ADDENDUM No. 2

ITB No. 4611

BIRD ROAD RETAINING WALL

CITY OF ANN ARBOR - PUBLIC SERVICES - ENGINEERING
BIRD ROAD RETAINING WALL
 REMOVALS

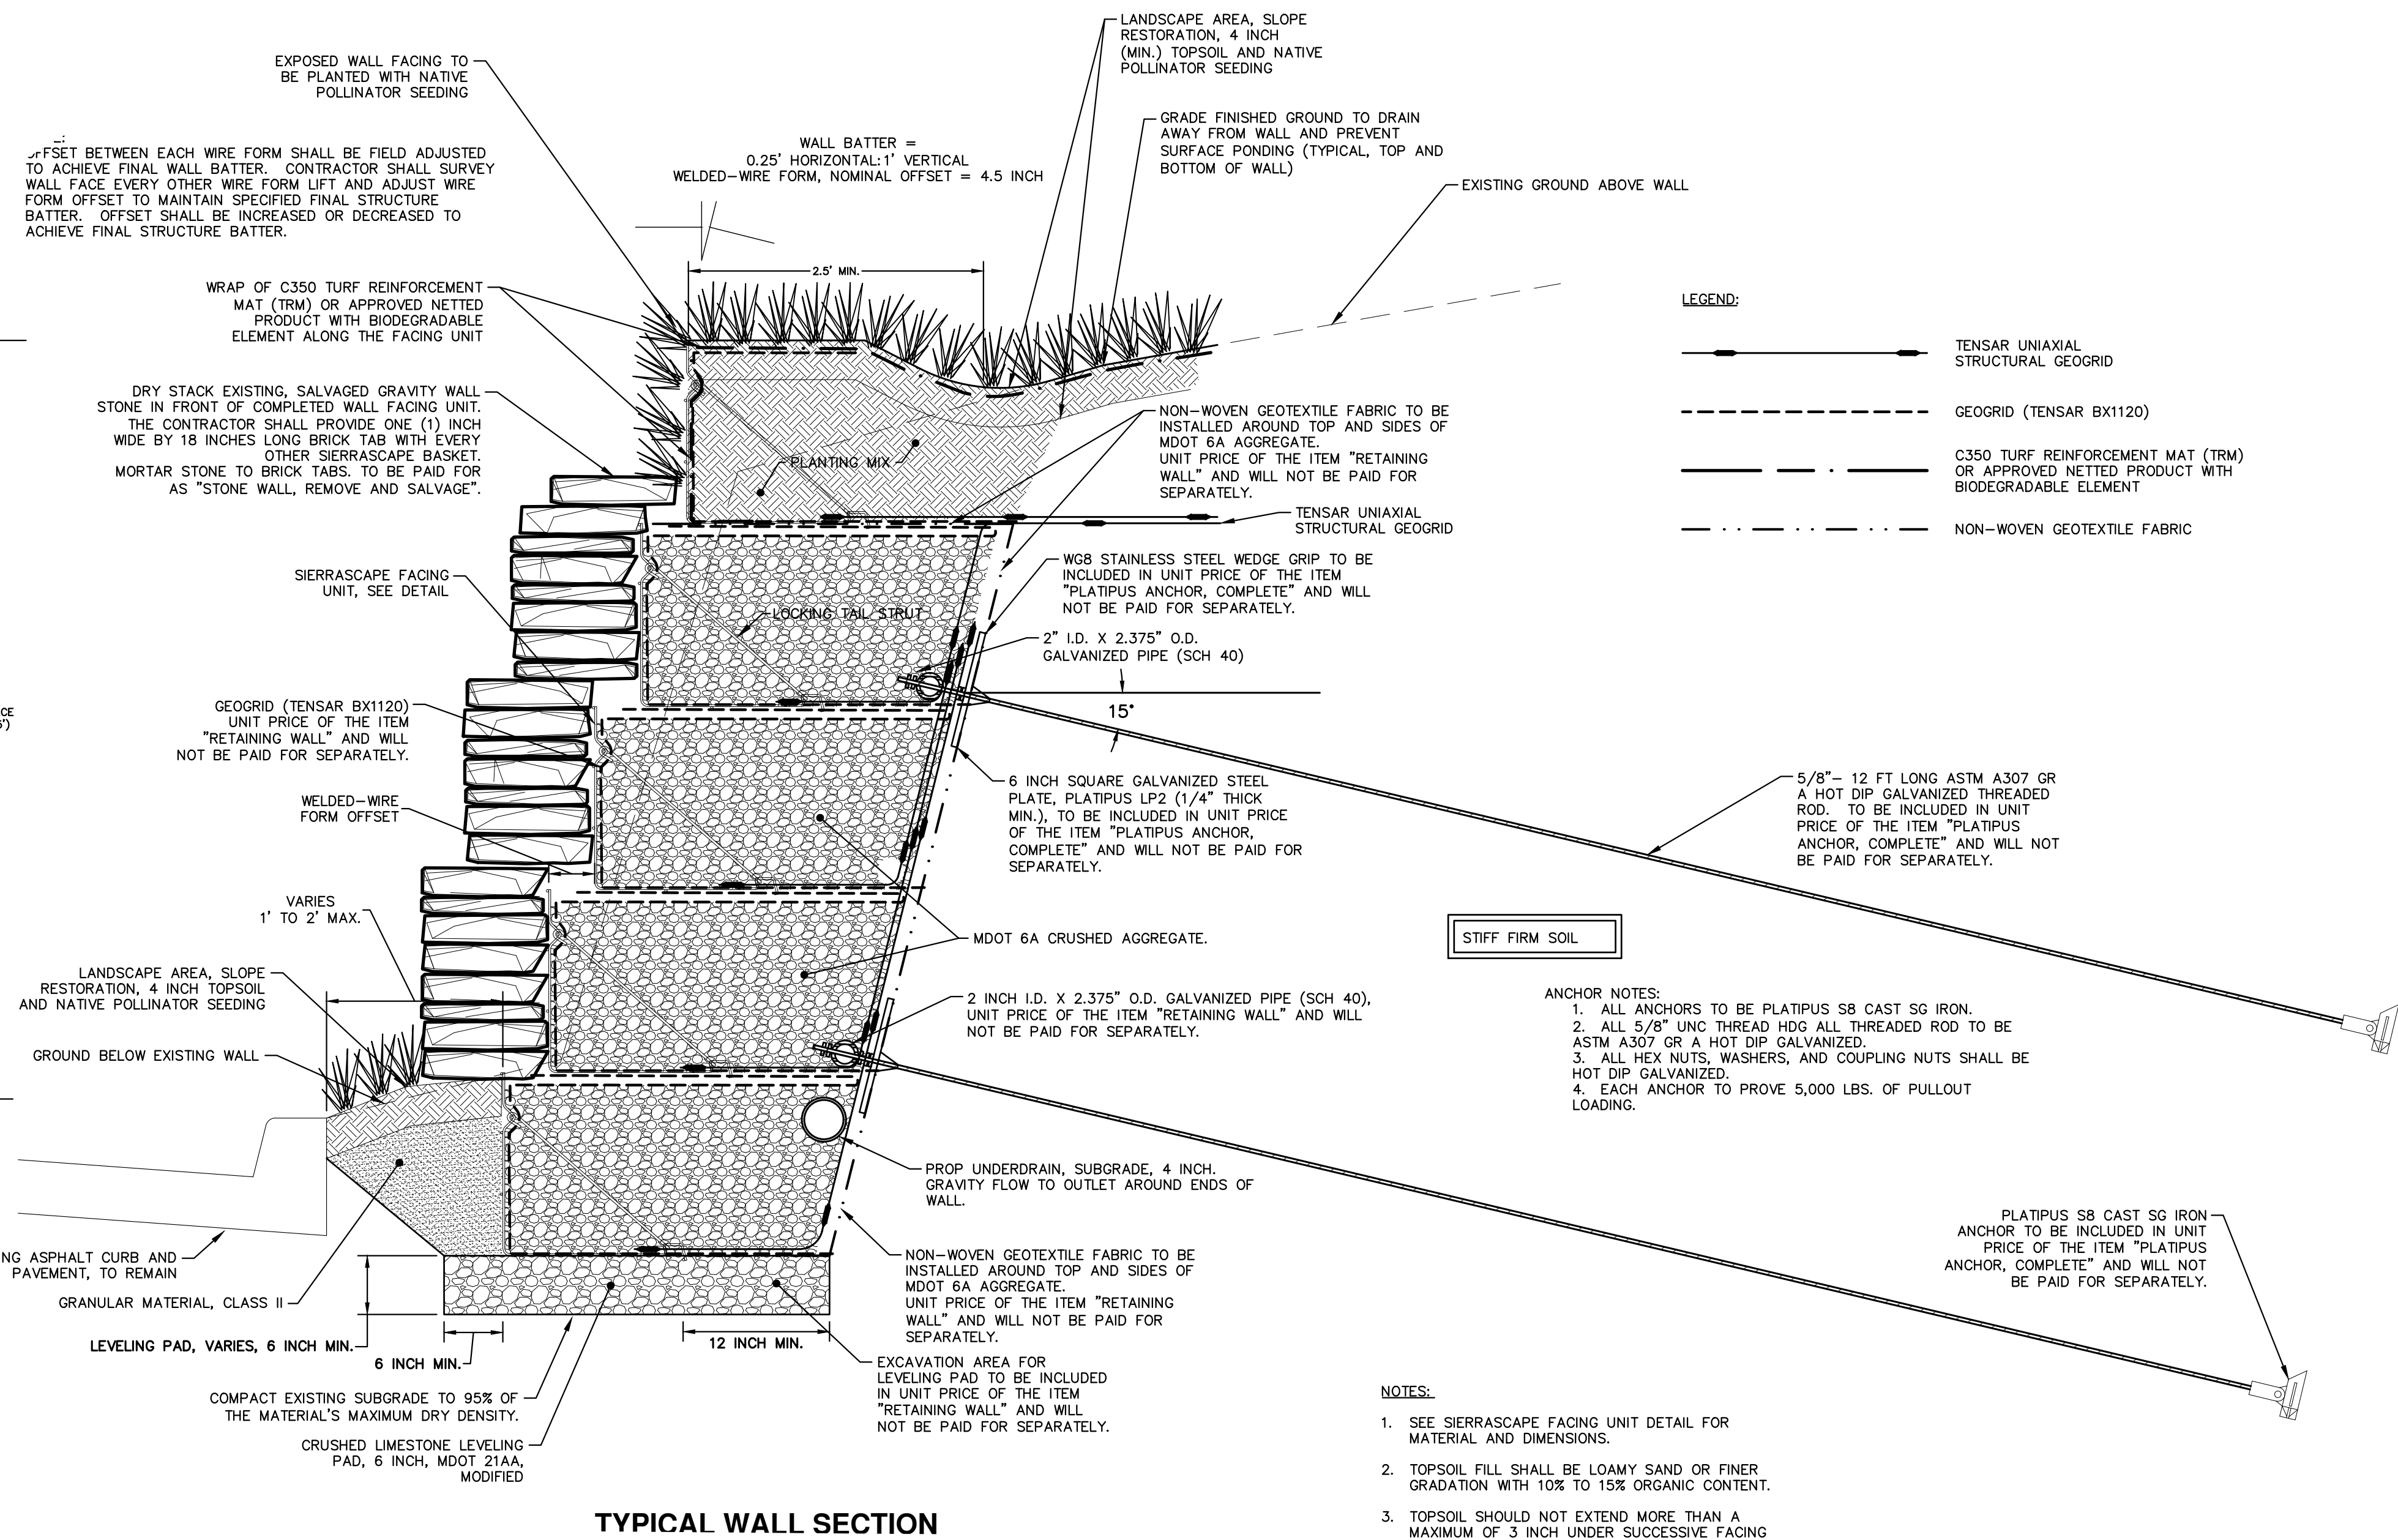
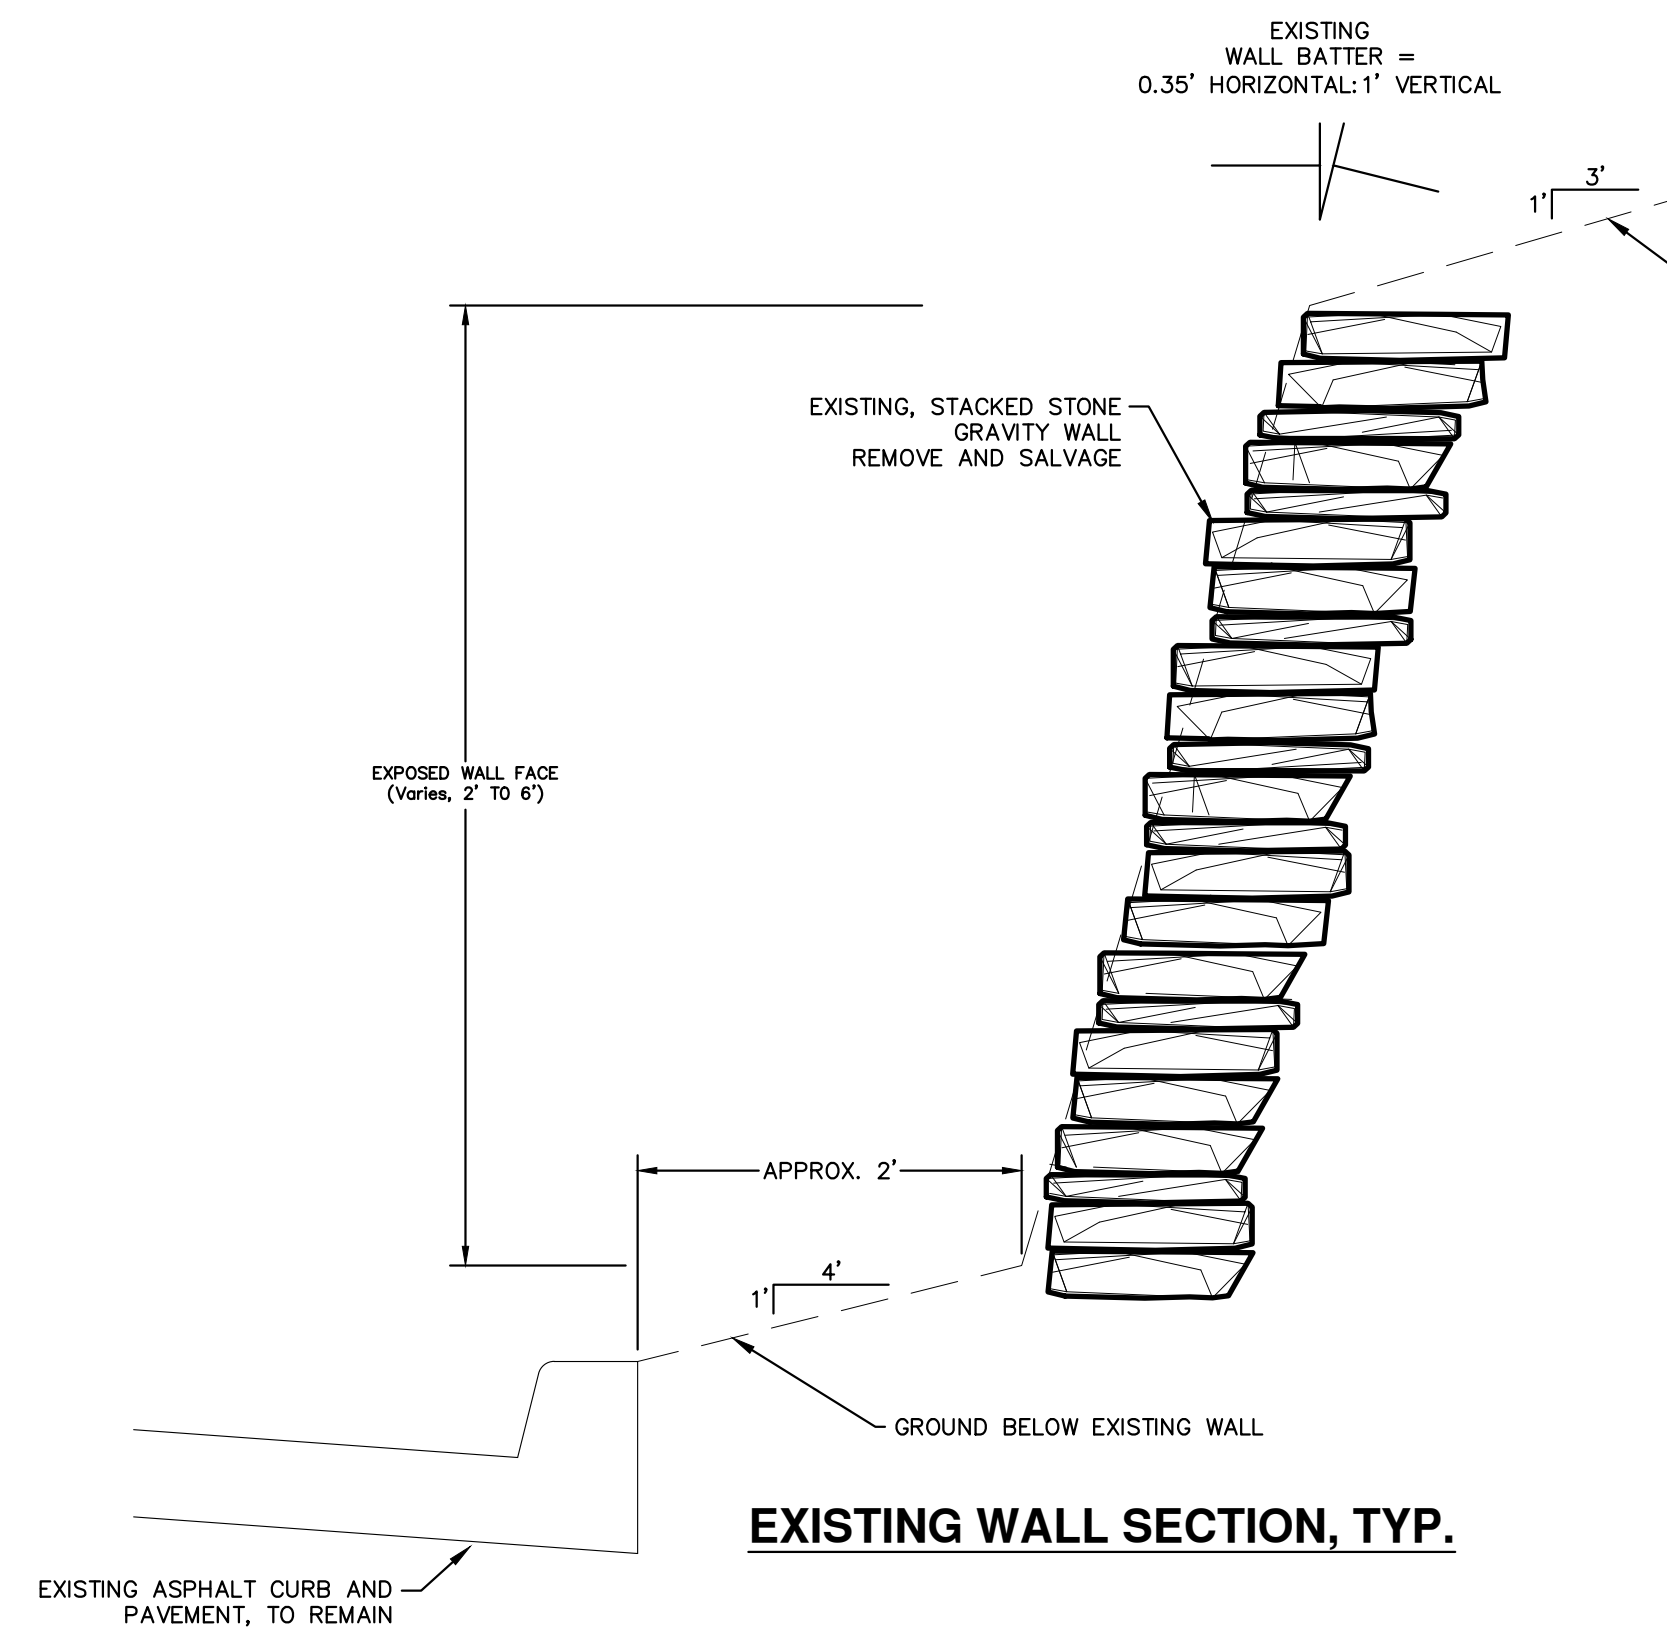
THE HOMEOWNER AT 1274 BIRD ROAD HAS A STOCKPILE OF STONES FROM THE EXISTING WALL. THE CONTRACTOR SHALL COORDINATE REMOVAL FROM THEIR PROPERTY, STOCKPILE AND REUSE THESE STONES IN THE FINAL WALL. THIS WILL BE PAID FOR AS "STONE WALL, REMOVE AND SALVAGE"

Sheet 4 - Details

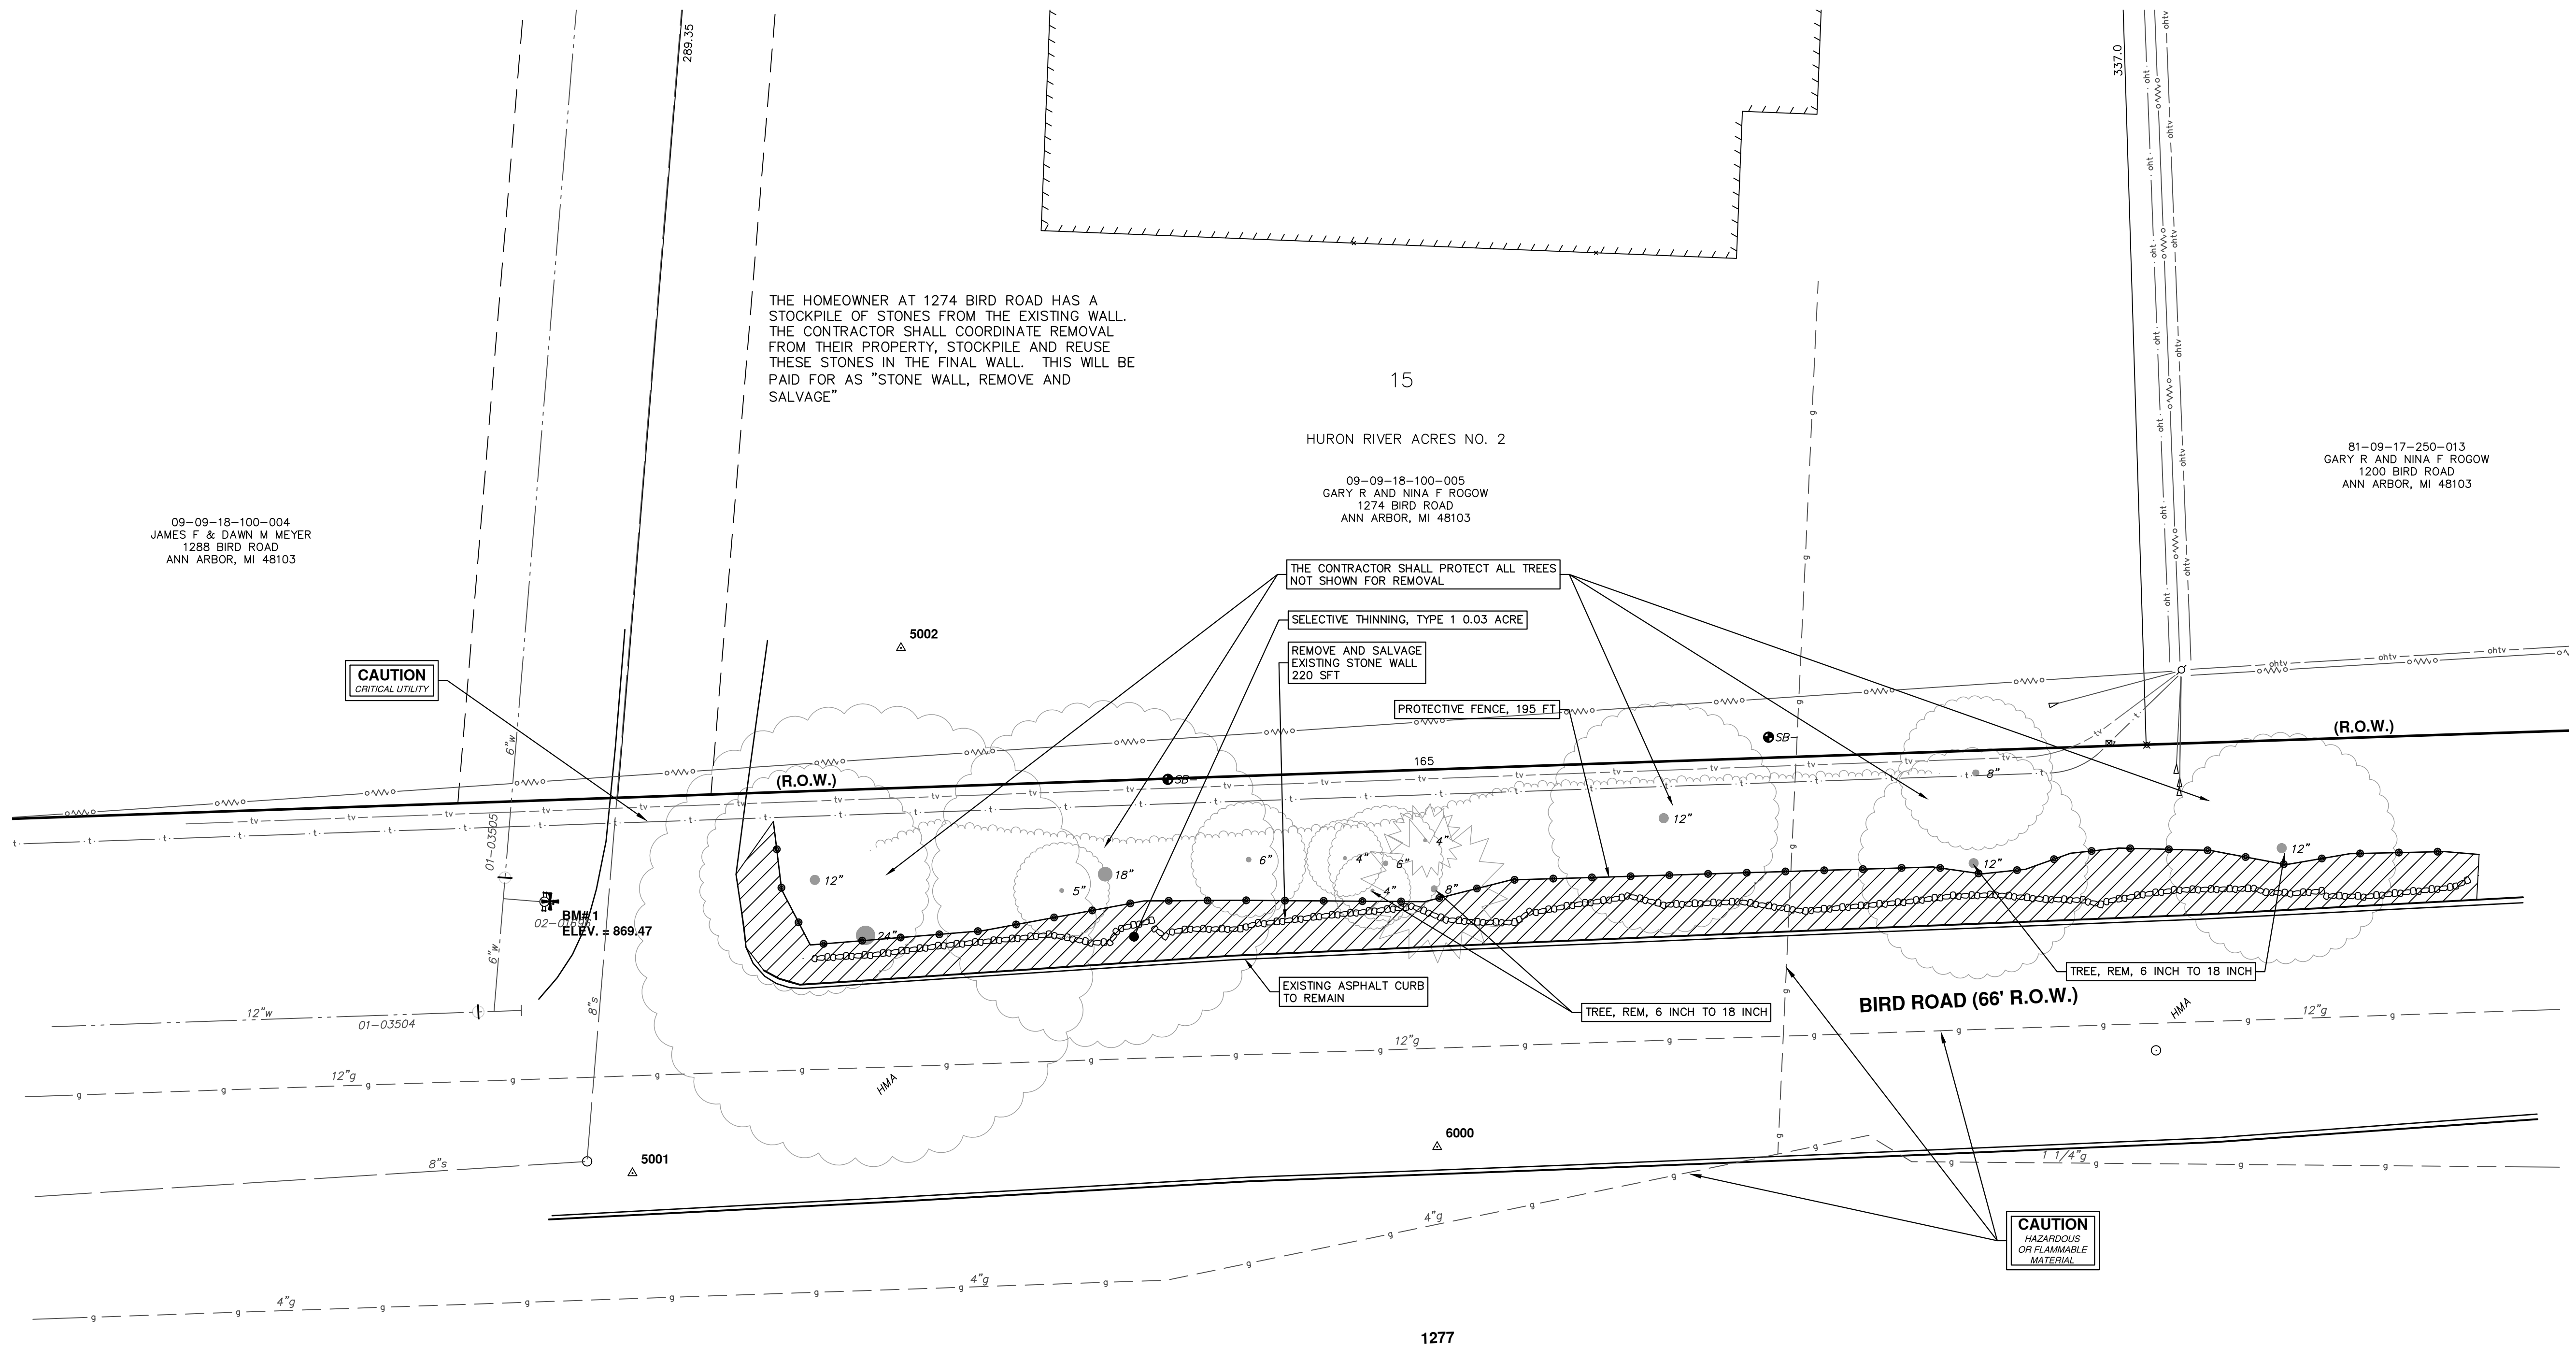
1. Is there a Platipus Anchor Schedule showing the minimum lengths and required capacities that you can provide?

4. On sheet 4 of the plans, can you provide a legend for the different linestyles?
The Typical Wall Section detail was updated to clean up the linework. In addition, a Legend was added to the detail.

10. How is the stone being connected to the basket?
a. What keeps the stone from pushing away from the basket face? -
A note was added to the Typical Wall Section requiring the addition of one (1) inch wide by eighteen (18) inch long brick tabs with every other Facing Unit. These tabs are to be mortared to the stone wall.

Note added to the Typical Wall section. Minimum length of each anchor rod to be 12 feet and is to provide a minimum of 5,000 lbs of pullout loading.

TENSAR UNIAXIAL STRUCTURAL GEOGRID
	GEOGRID (TENSAR BX1120)
	C350 TURF REINFORCEMENT MAT (TRM) OR APPROVED NETTED PRODUCT WITH BIODEGRADABLE ELEMENT
	NON-WOVEN GEOTEXTILE FABRIC

- ANCHOR NOTES:
1. ALL ANCHORS TO BE PLATIPUS S8 CAST SG IRON.
 2. ALL 5/8" UNC THREAD HDG ALL THREADED ROD TO BE ASTM A307 GR A HOT DIP GALVANIZED.
 3. ALL HEX NUTS, WASHERS, AND COUPLING NUTS SHALL BE HOT DIP GALVANIZED.
 4. EACH ANCHOR TO PROVE 5,000 LBS. OF PULLOUT LOADING.
